**Re: 40 to 60 Emma Street  
Comments for Site Plan Stage  
Project No.: 300056012.0000**

The application will be required to obtain site plan approval. As comments related to the site plan stage are more detailed, these comments have been provided separately from the Official Plan/Zoning Amendment applications.

Enclosure(s)      Red-Marked Pages from Servicing Brief

SHEET NUMBER:  
ESC-1

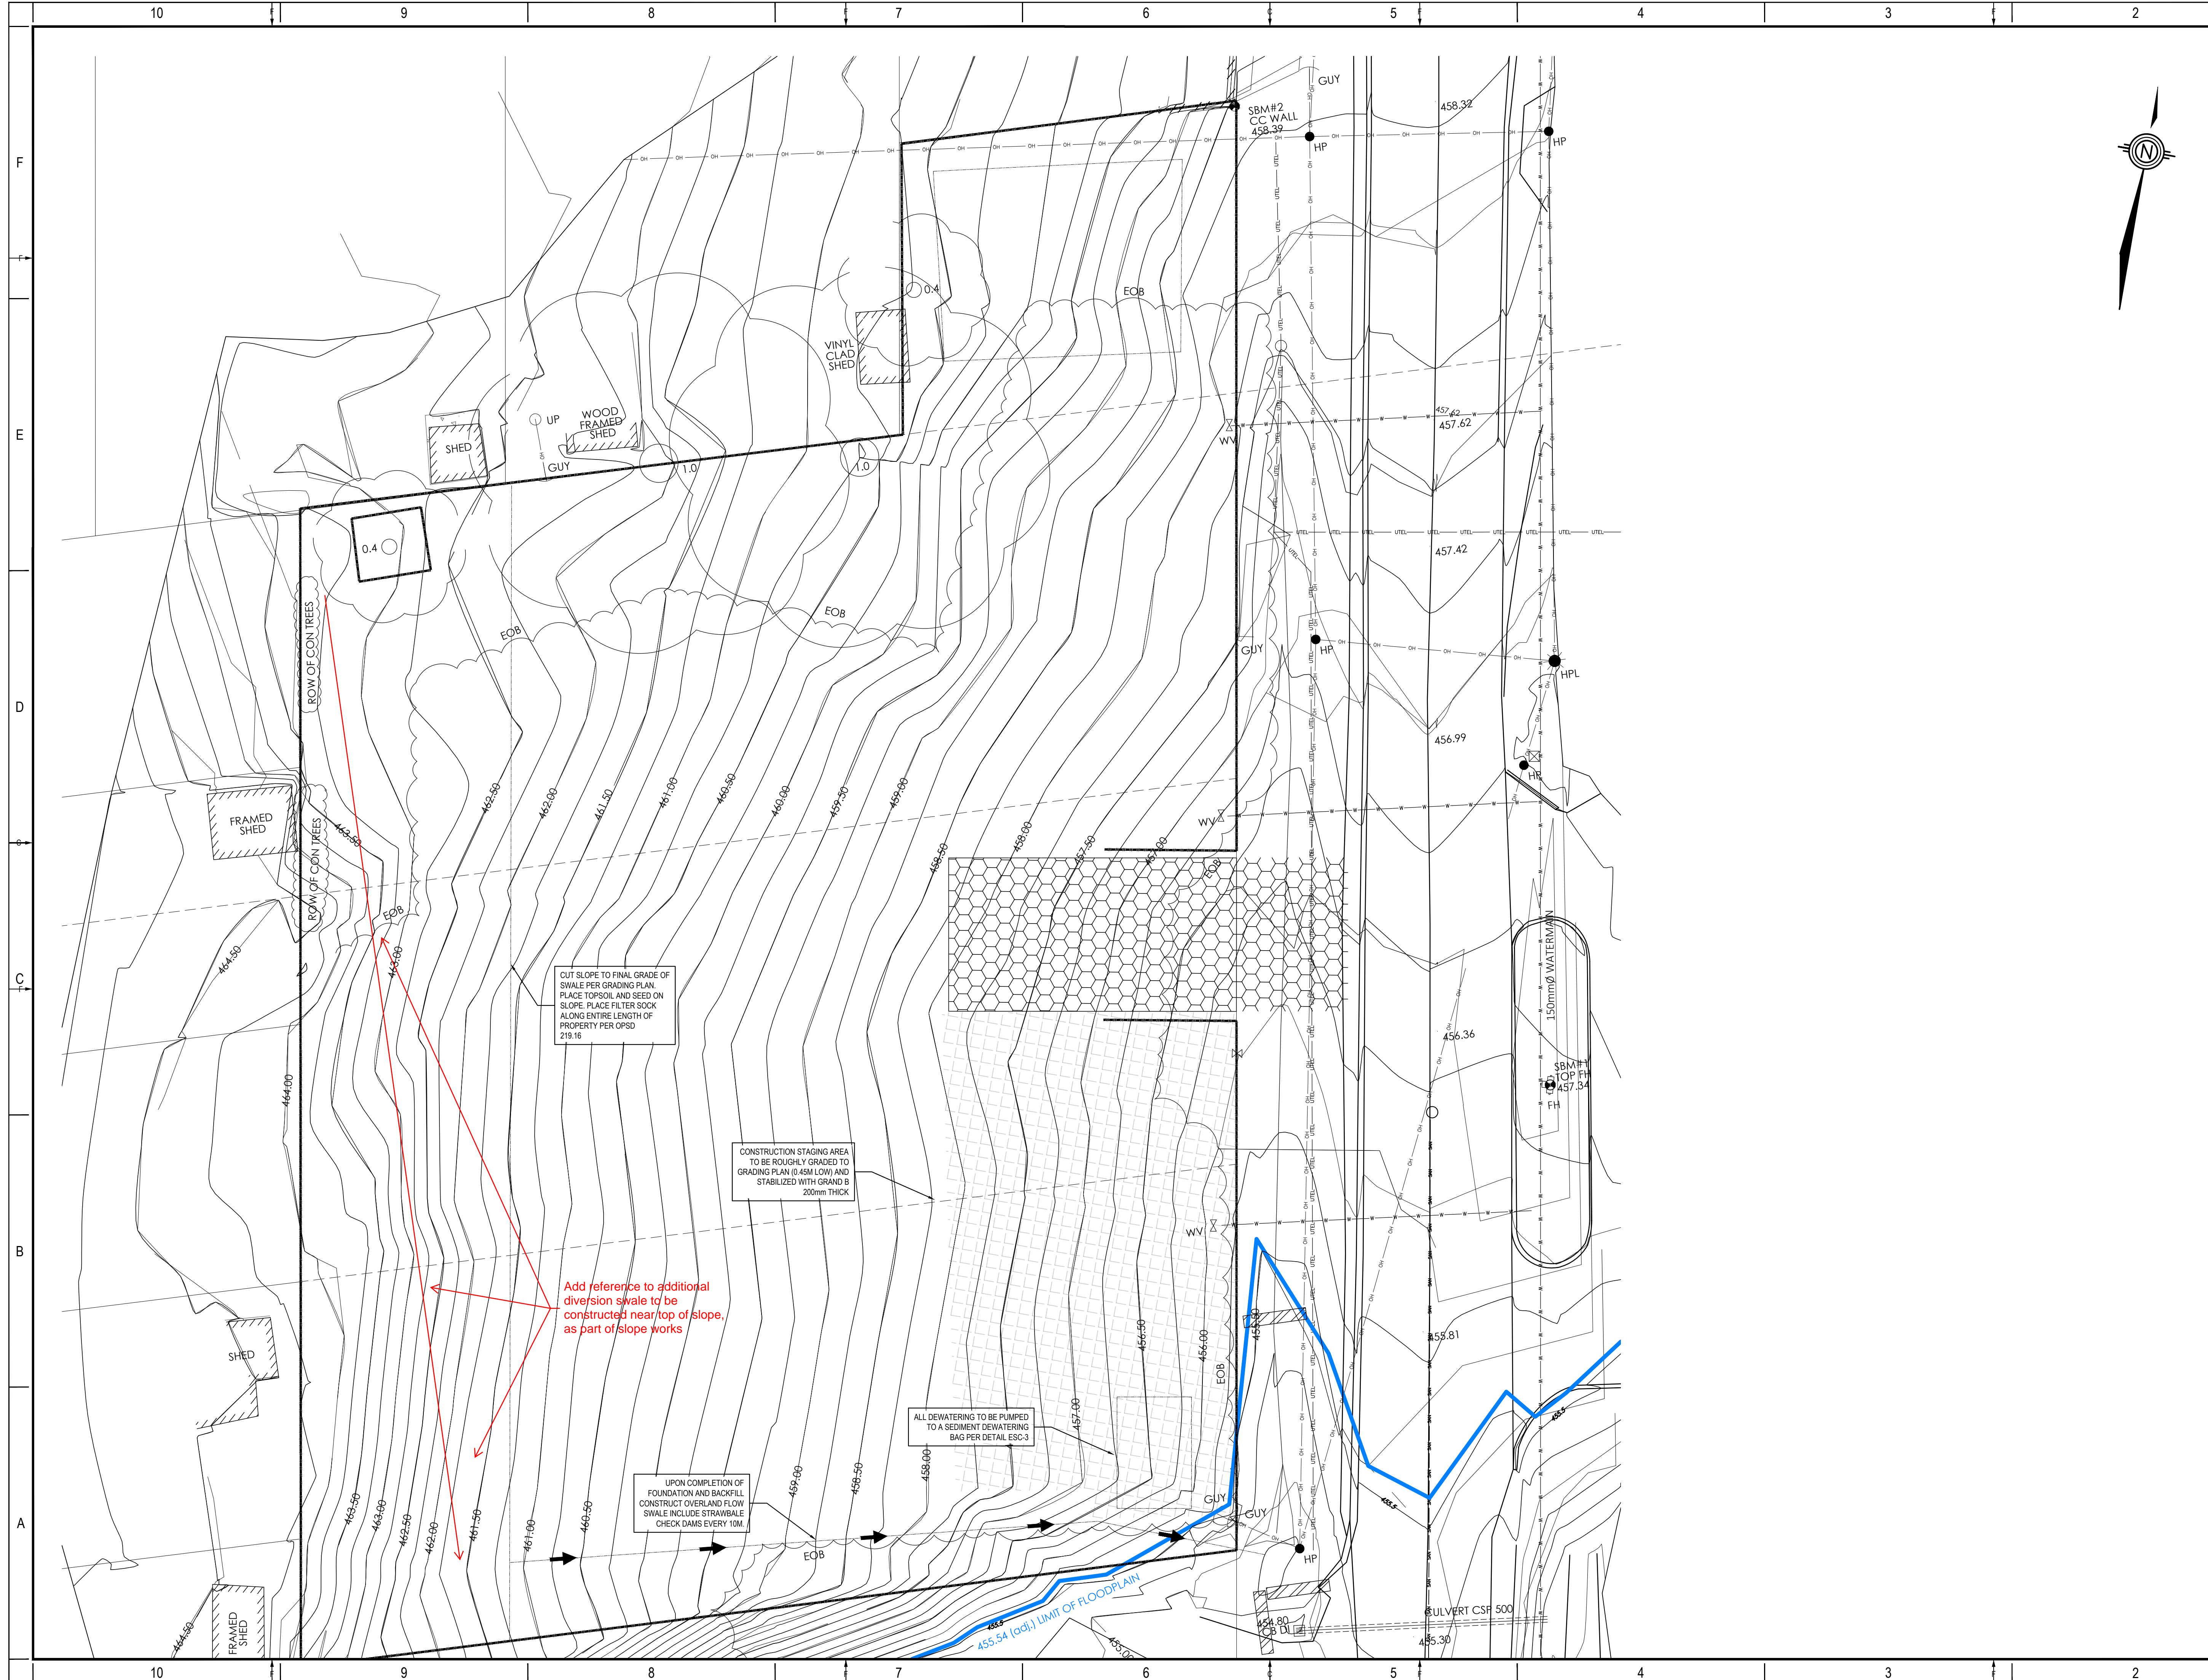
Complete tree removal/grubbing first, but focus on the west side of site first and re-seed then get into entire site topsoil stripping for construction.

Do not disturb during Stage 1 - Install Silt socks intermittently along existing ditch

Cut in small temporary swale to minimize ponding up to edge of roadway. Stabilize after installation.

SHEET NUMBER:  
GRAD-1

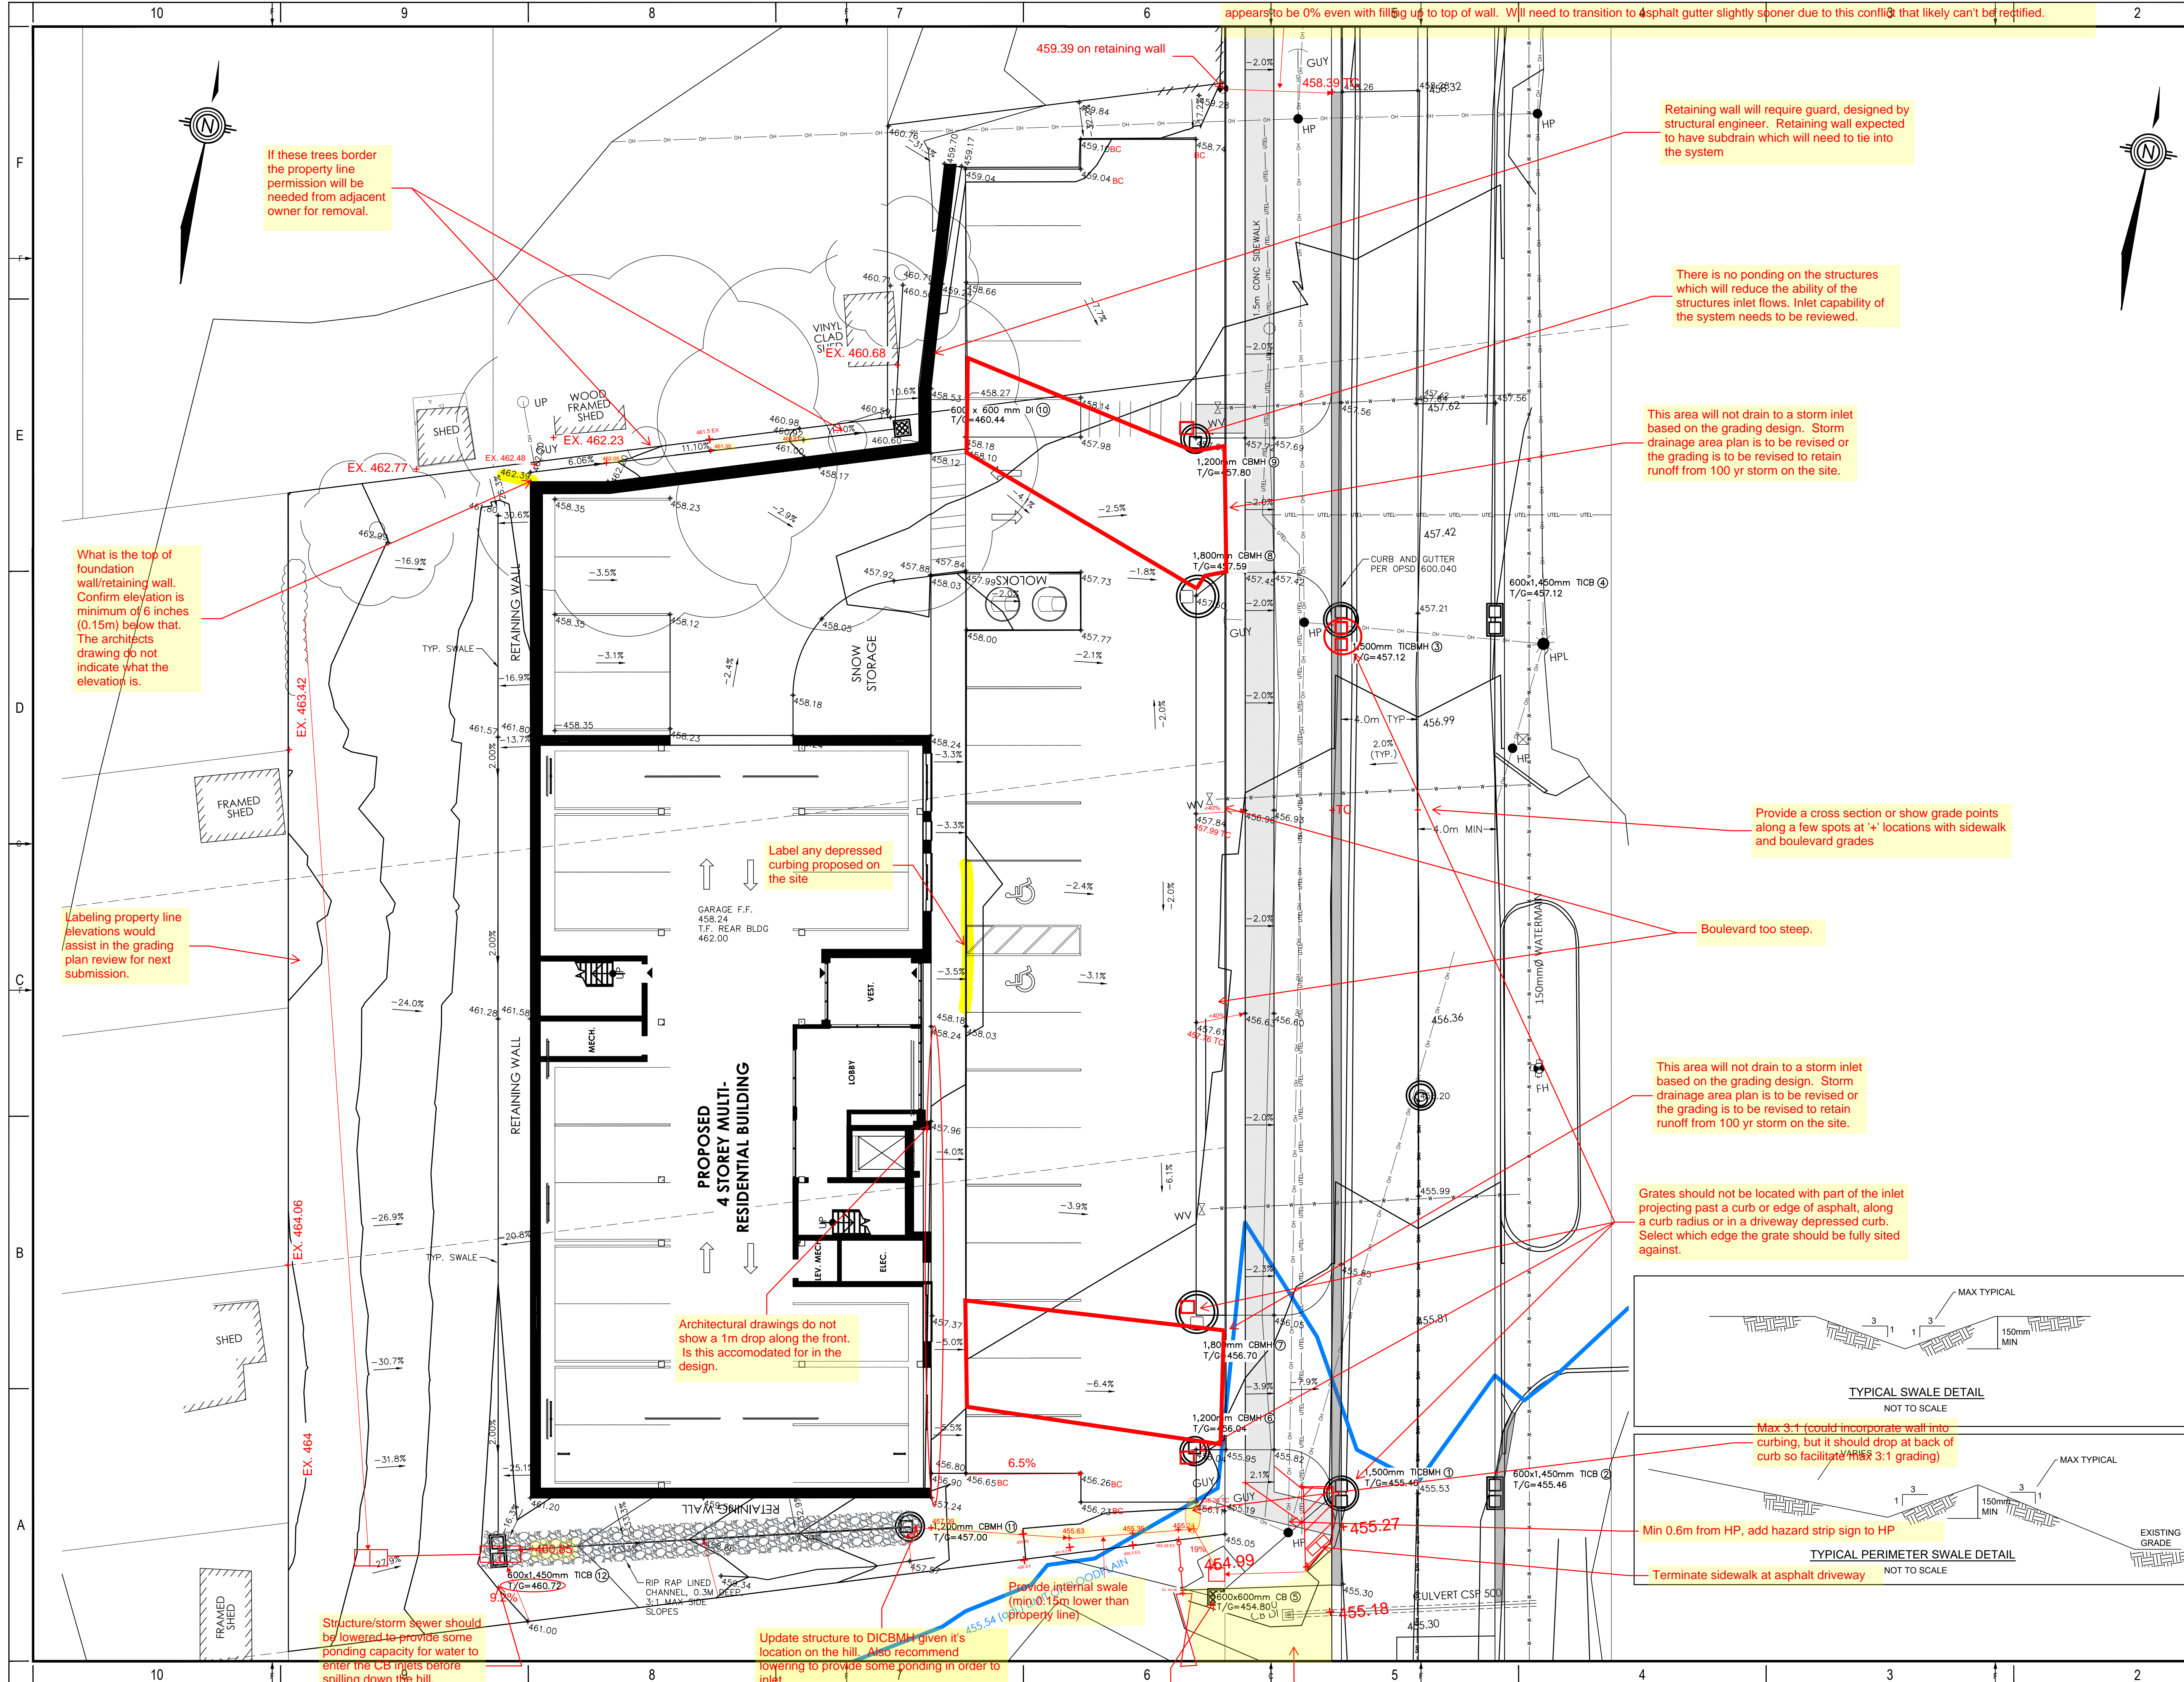
Drawings for site plan approval will need to have general notes page indicating all specs.

If these trees border the property line permission will be needed from adjacent owner for removal.

What is the top of foundation wall/retaining wall. Confirm elevation is minimum of 6 inches (0.15m) below that. The architects drawing do not indicate what the elevation is.

Labeling property line elevations would assist in the grading plan review for next submission.

Architectural drawings do not show a 1m drop along the front. Is this accommodated for in the design.

Structure/storm sewer should be lowered to provide some ponding capacity for water to enter the CB inlets before spilling down the hill. Consider changing structure to DICB.

Update structure to DICBMH given its location on the hill. Also recommend lowering to provide some ponding in order to inlet

Should not be within the potential access.

Will be required to grade/re-asphalt - Provide straight line from edge of gate out to road to meet up with sidewalk termination. Would need to discuss with Owner similar to new CB.

This area will not drain to a storm inlet based on the grading design. Storm drainage area plan is to be revised or the grading is to be revised to retain runoff from 100 yr storm on the site.

Provide a cross section or show grade points along a few spots at '+' locations with sidewalk and boulevard grades

This area will not drain to a storm inlet based on the grading design. Storm drainage area plan is to be revised or the grading is to be revised to retain runoff from 100 yr storm on the site.

Max 3:1 (could incorporate wall into curbing, but it should drop at back of curb so facilitate max 3:1 grading)

Min 0.6m from HP, add hazard strip sign to HP

Terminate sidewalk at asphalt driveway
